Product Change Notification

PCN-FDC-6424-2020

Business Unit	Product Line Code	Type of Change	Action	Date of Issue
FDC - Field Device Connectors	ABQ	Product Change Notification	Notify Distributors and Field	12/23/2020

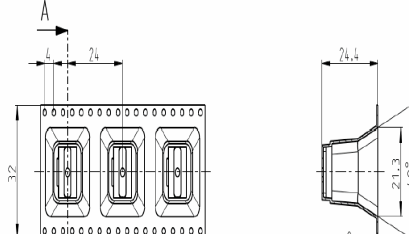
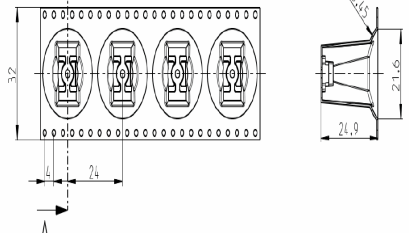
The tape-on-reel packaging of unshielded M8 SMD items has been changed slightly to make the feed-in process for SMD components smoother. The dimensional changes are shown in the attached document. Both the pocket depth and also the geometry of the pocket have been optimized to ensure the stable fit of the components in the tape-on-reel packaging. The insulating bodies now sit higher in the tape-on-reel packaging, therefore optimizing the gripping or suction action. This change has no effect on the technical properties of the connectors. The timely implementation of this change is therefore necessary. If you have any questions or need our support due to this changeover, contact the sales team responsible.
